LSD Gardner Food Service

Bid Pack 2, Addendum No. 1

Narrative of Changes

Project Name:	Gardner Elementary Food Service – Equipment Replacement & Renovations SO-1852	Date:	April 3, 2026
Project Location:	333 Dahlia Dr, Lansing, MI 48911	Architect's Project #:	26000752A
Owner/Client:	Lansing School District	Attention:	David Beckering
Issued to:	Beckering Construction	Email:	djb@beckering.com
City/State:	Grand Rapids, MI	Zip:	49548

DRAWING NUMBER: G001

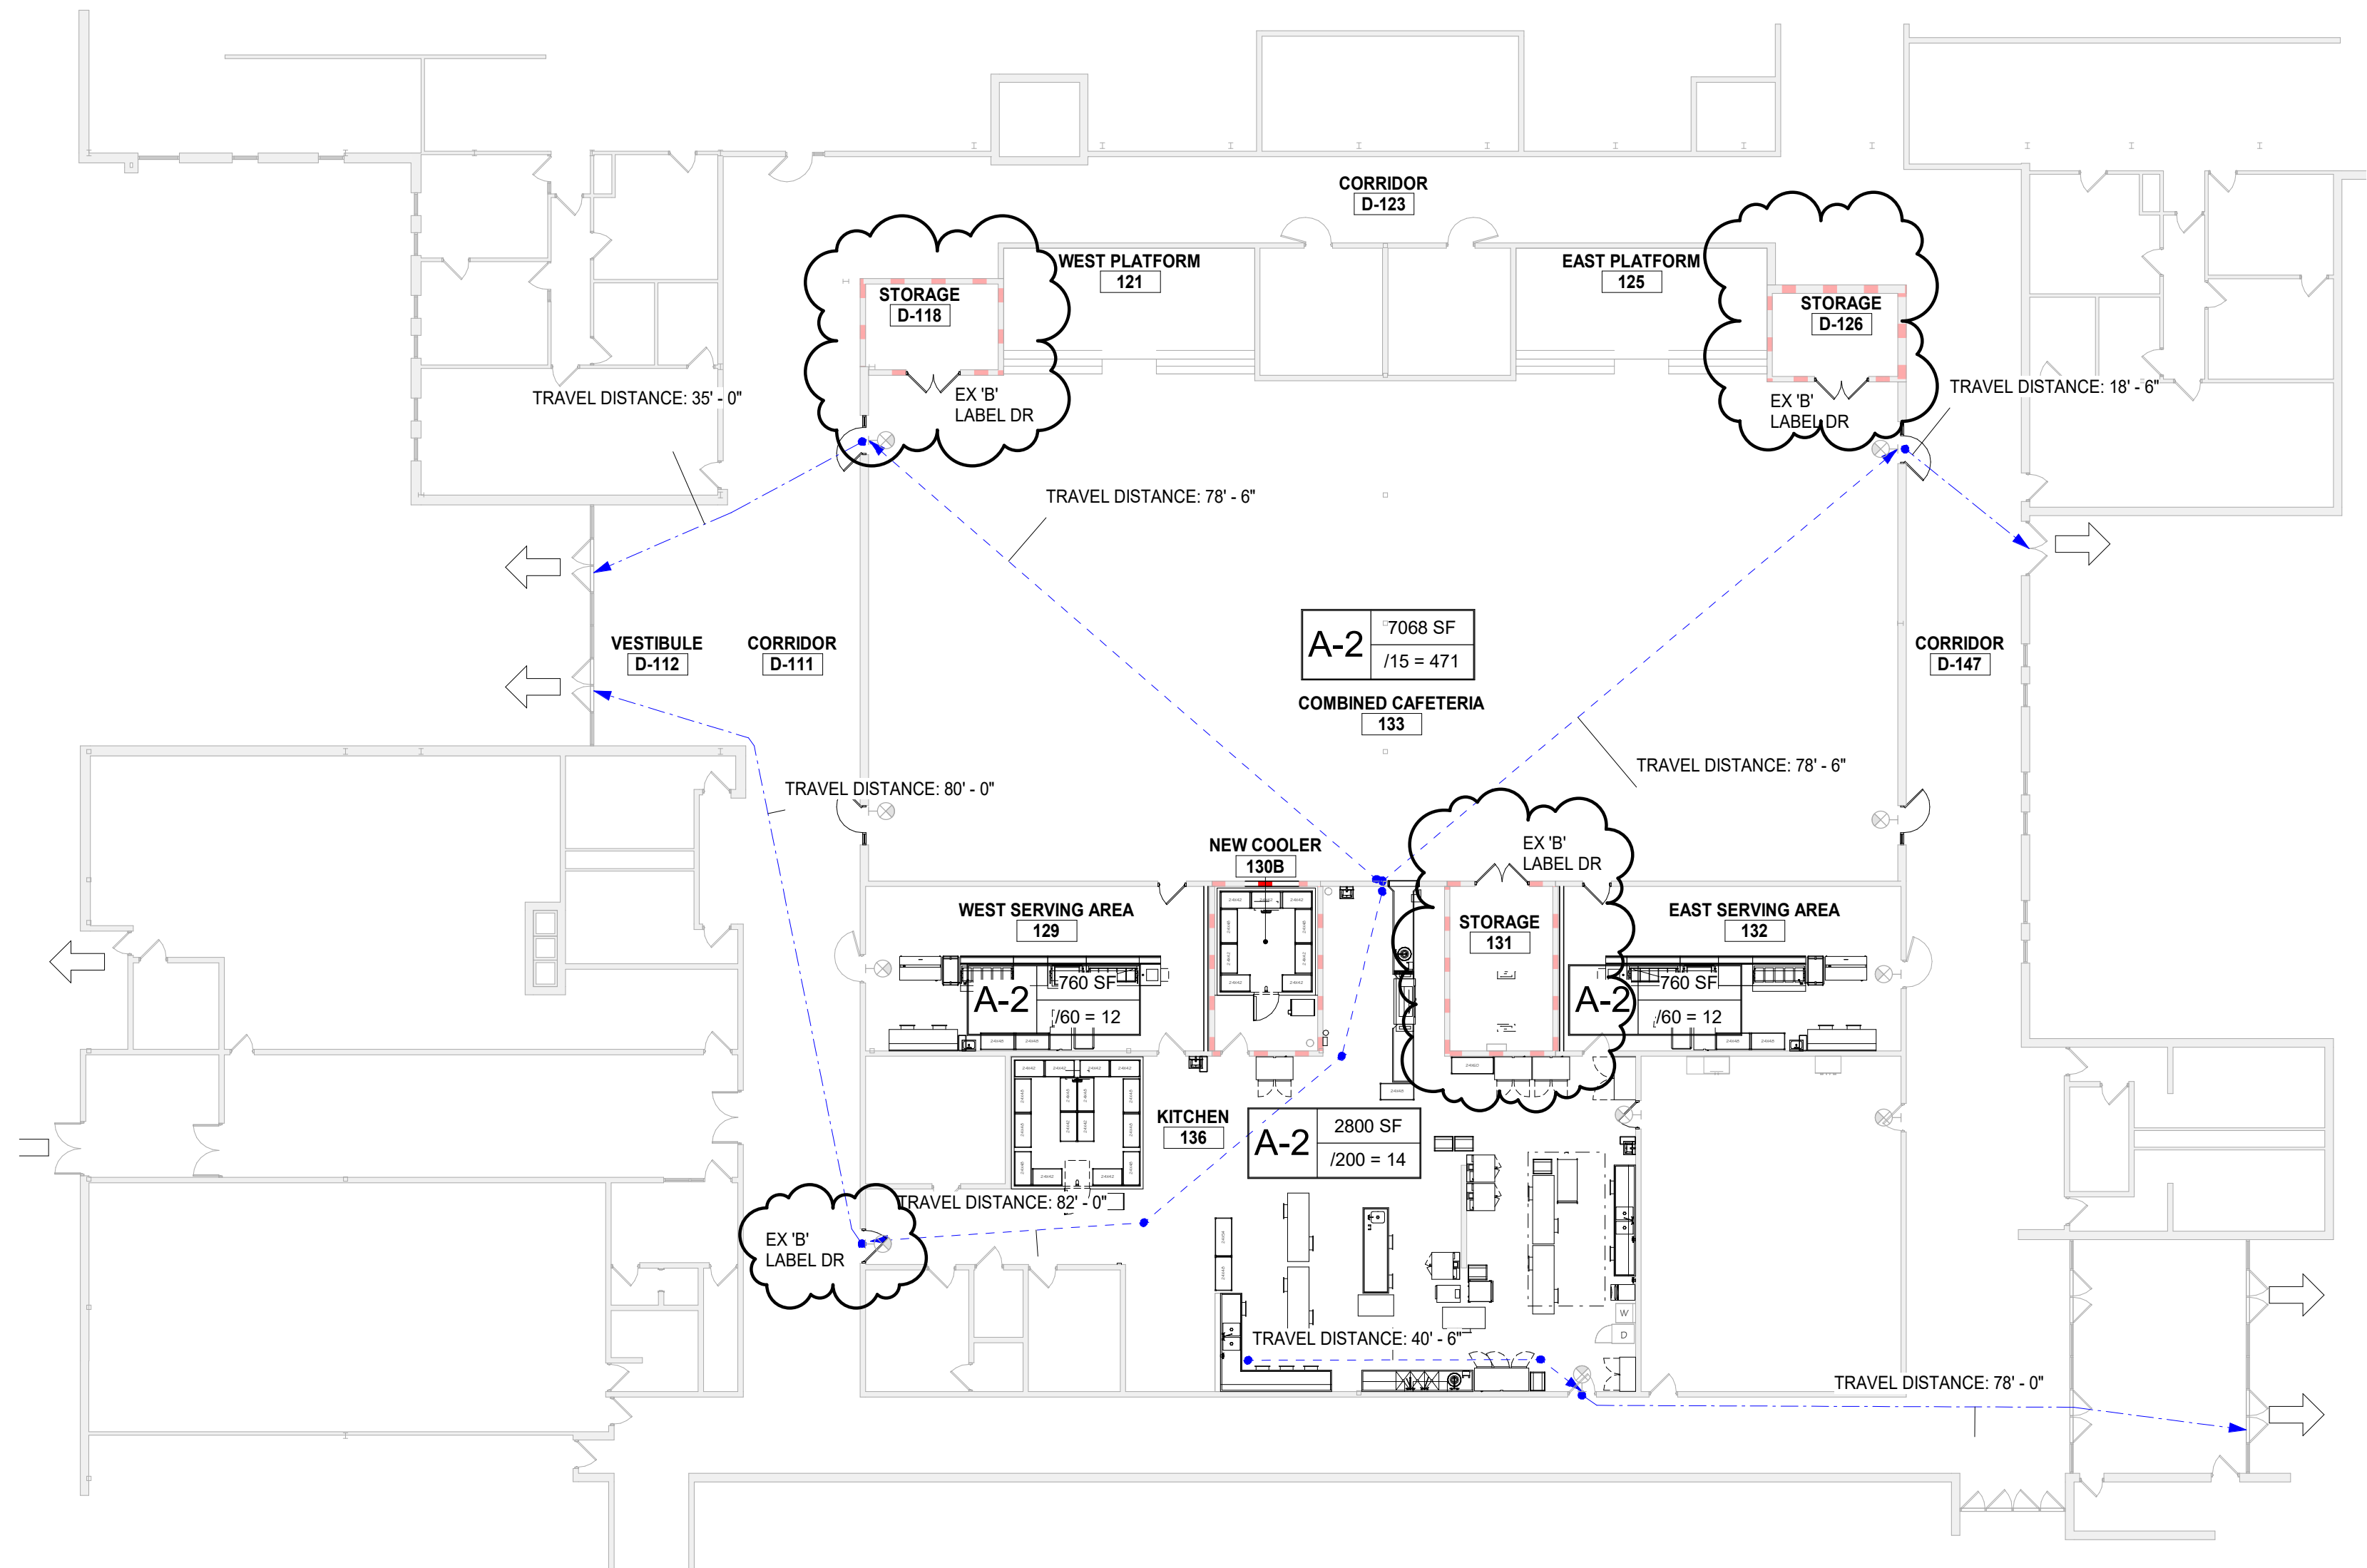
- G001 – CODE COMPLIANCE & LIFE SAFETY PLANS
 - Added notes about existing 'B' labeled rated doors
- A141 – FIRST FLOOR FINISH PLAN (Reissued)
 - Removed paint tag from bubbled door. All hm door frames and HM doors to get painted. Existing wood doors remain unpainted. New wood doors are factory finished. Doors not in the door schedule have been noted on sheet A141 as to what gets painted.

DRAWING NUMBER: **E100**

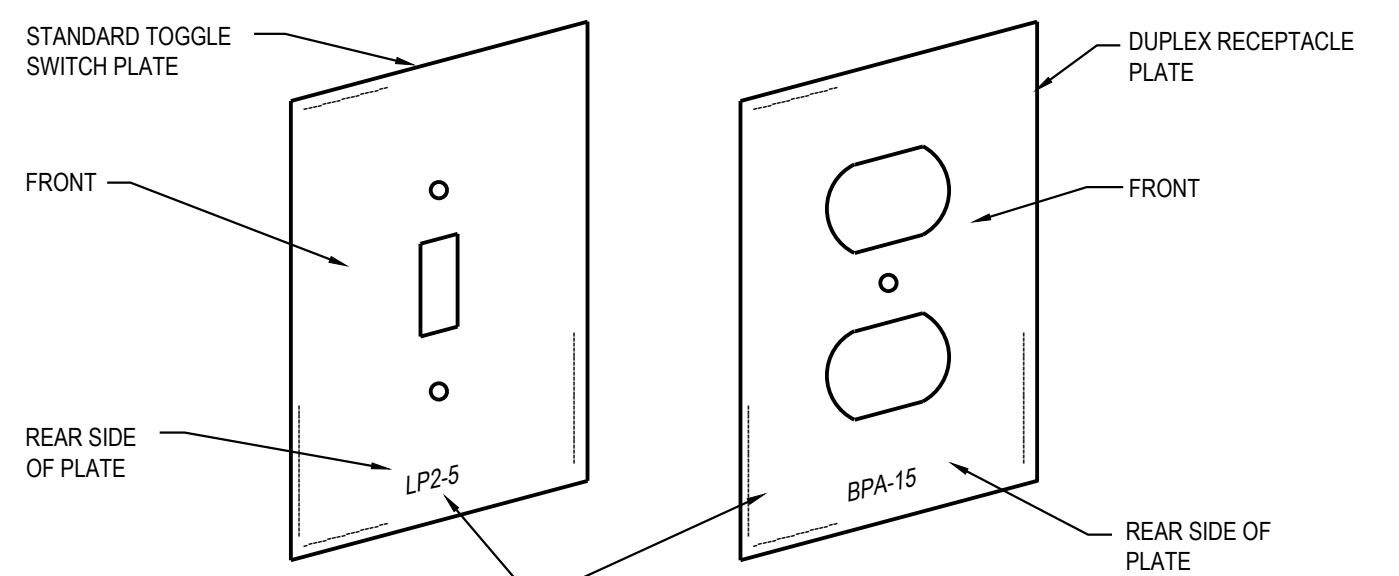
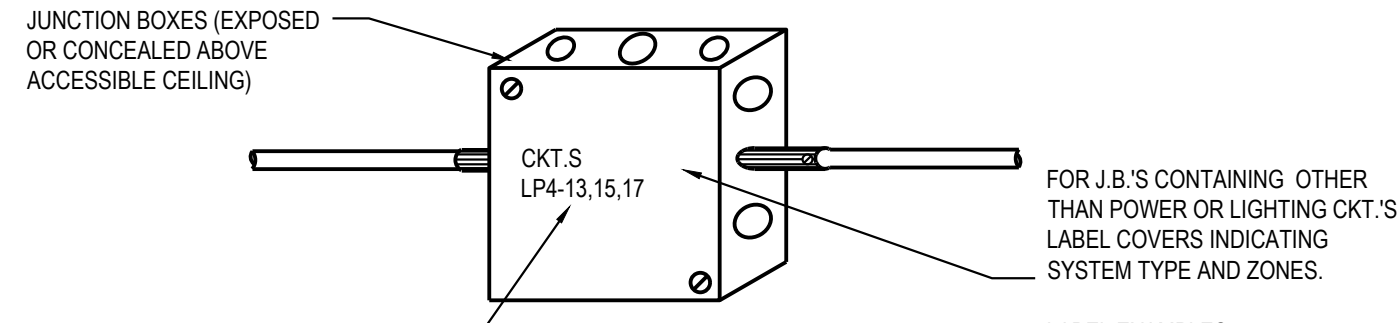
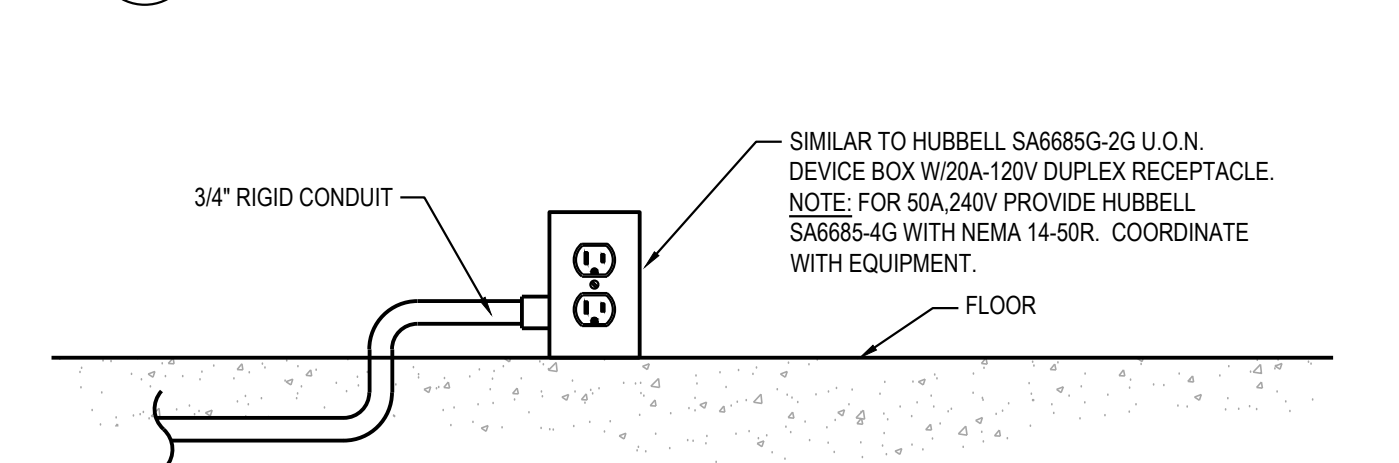
- E100 – DETAILS, SYMBOL LEGEND & SPECIFICATIONS (Reissued)
 - Changed type B to Lumenwerx 1500 Lumen per LF
 - Watt stopper is approved for lighting controls

- Williams, Columbia approved lighting manufactures
